G-3837

Subject: Response to November 18, 2015, Geotechnical Third Party Review Letter,
Proposed Residence, 5637 East Mercer Way, Mercer Island, Washington.

Reference: Geotechnical Third Party Review, 5637 E. Mercer Way, Mercer Island,
Washington (Perrone Consulting Project #15124). Perrone Consulting, Inc., P.S.,
November 18, 2015.

<i>Project</i> SLIDE - An Interactive Slope Stability Program		
	<i>Analysis Description</i> MI Treehouse - Existing Condition, Static Case		
	<i>Drawn By</i> KJ	<i>Scale</i> 1:1338	<i>Company</i>
	<i>Date</i> 2/4/2016	<i>File Name</i> MI 1.slim

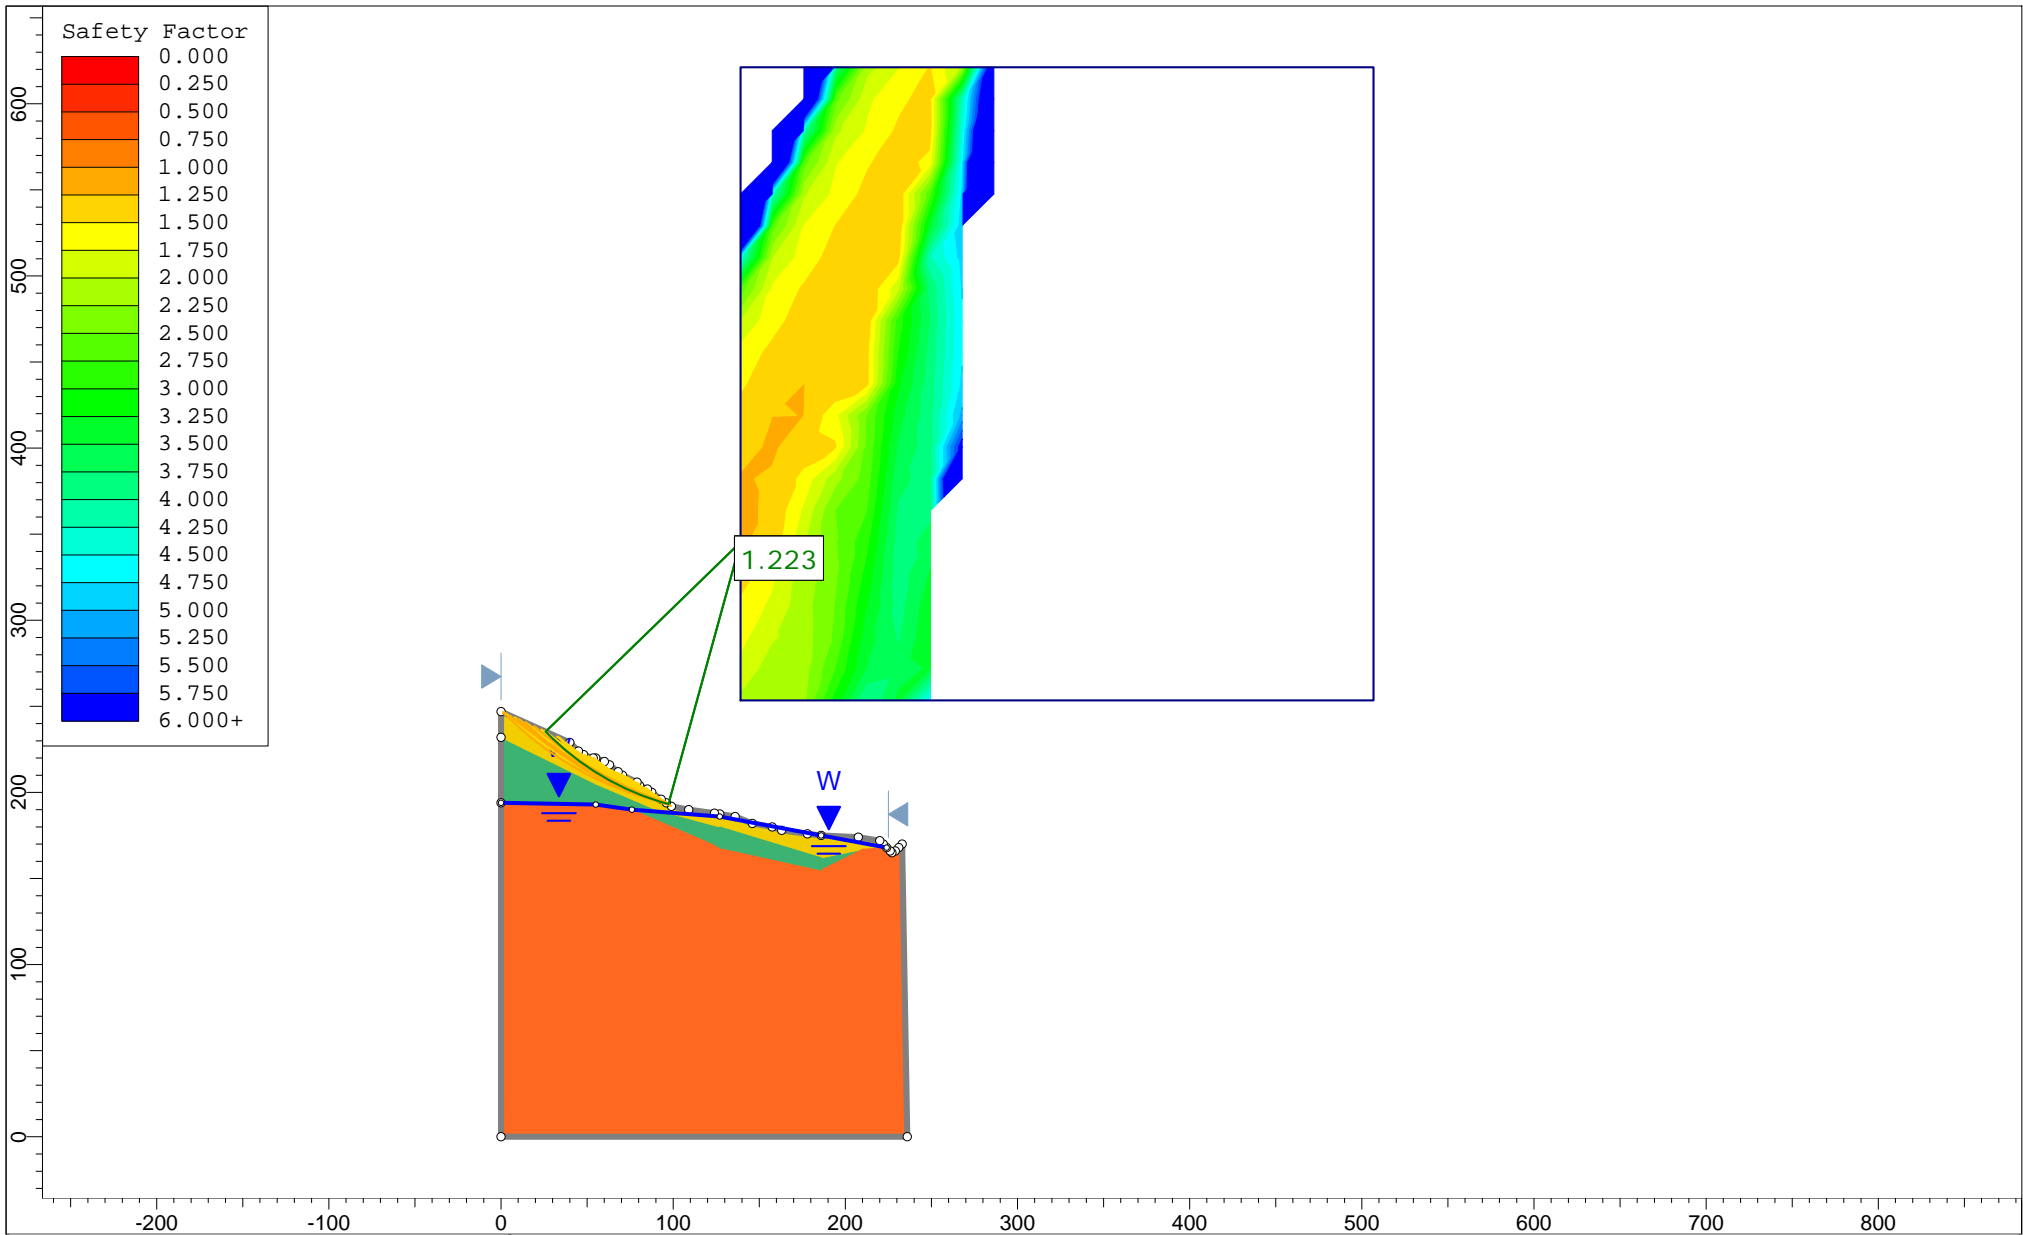
Comment #3: Additional Slope Stability Analysis

Additional stability analysis was performed for the site profile A-A' following receipt of the November 18, 2015, review comments. For the additional analyses, the SPT data obtained for the borings were adjusted for soil overburden effects, using the methodology described by Liao and Whitman (1986)¹. Analysis for the seismic case was modified to consider a lateral peak ground acceleration of 0.6g, instead of the 0.3g used in our previous analysis. A pseudo-static seismic coefficient, k_h , of 0.15 was used for the analysis, following recommendations from research by Melo and Sharma (2004)², instead of the typical assumed value of 0.5. The analyses were performed using the Slide 7.0 computer software program using the same material properties and the Bishop method of vertical slices as previously used in the XSTABL analysis.

The additional stability analysis calculations indicate that the slope profile has an FS value of 1.22 for stability in its existing configuration for the static case, and an FS value of 1.01 for the modeled seismic case. The small change in the static-case FS value is attributed to minor adjustments in the soil layer thicknesses resulting from using the adjusted SPT data. The increase in the seismic-case FS value is due to the use of the updated peak ground acceleration and seismic coefficient values used for the analysis.

For both the static and seismic cases, the most critical failure surfaces for the existing slope condition consist of arc-shaped failures that involve the loose sand soils. These failure surfaces generally are limited to the unsaturated soils upslope from the proposed residence location in the static case. These most critical failure surfaces are illustrated in the analysis plots provided in Attachment 1.

Based upon the results from the subsurface investigation and slope stability analysis that we have completed, it is our opinion that the existing steep slope in proximity to the proposed residence location is relatively stable under static conditions, with the exception of some possible surficial raveling if exposed or disturbed.

<i>Project</i> SLIDE - An Interactive Slope Stability Program		
	<i>Analysis Description</i> MI Treehouse - Temporary Excavation, Static Case		
	<i>Drawn By</i> KJ	<i>Scale</i> 1:1338	<i>Company</i>
	<i>Date</i> 2/4/2016	<i>File Name</i> MI 2.slim

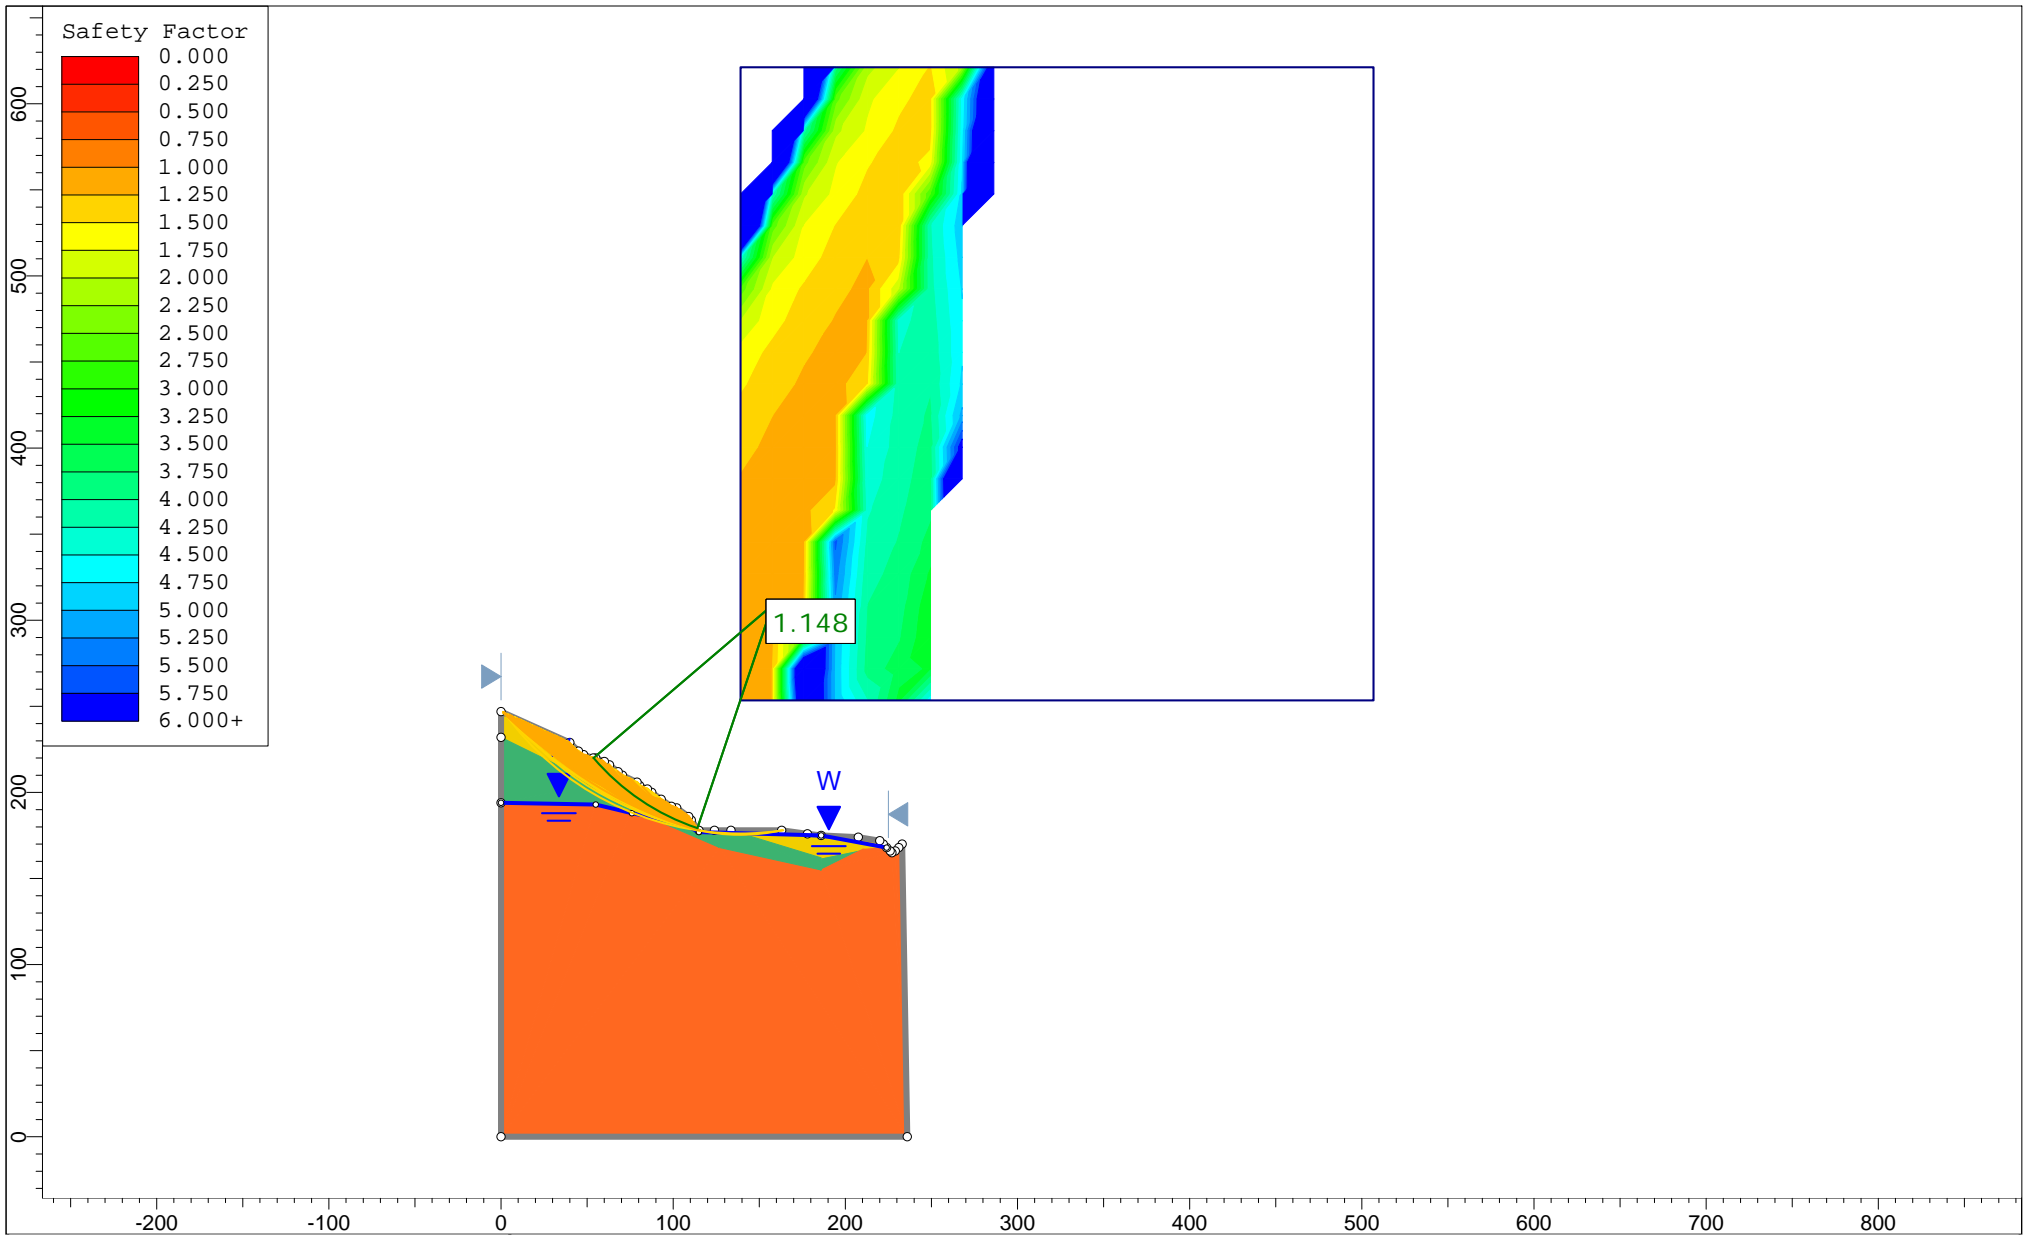
Temporary Excavation during Construction

We recommend that passive shallow dewatering be performed at the start of construction by using shallow trenches/swales at southeast, south, and west perimeter of disturbance area. The trenches should be sloped to drain toward stream. Staged deepening of excavation for the working pad for building can then be performed as the lowering of the water table proceeds. We recommend that the temporary excavation slopes be limited to 1H:1V in inclination and that they be backfilled to approximate original grade after the building foundations and walls have been constructed and restrained. The results of slope stability analysis of this temporary configuration indicate a static condition factor of safety of 1.15 provided that dewatering of the excavation area is achieved. The stability analysis results are provided in Attachment 1.
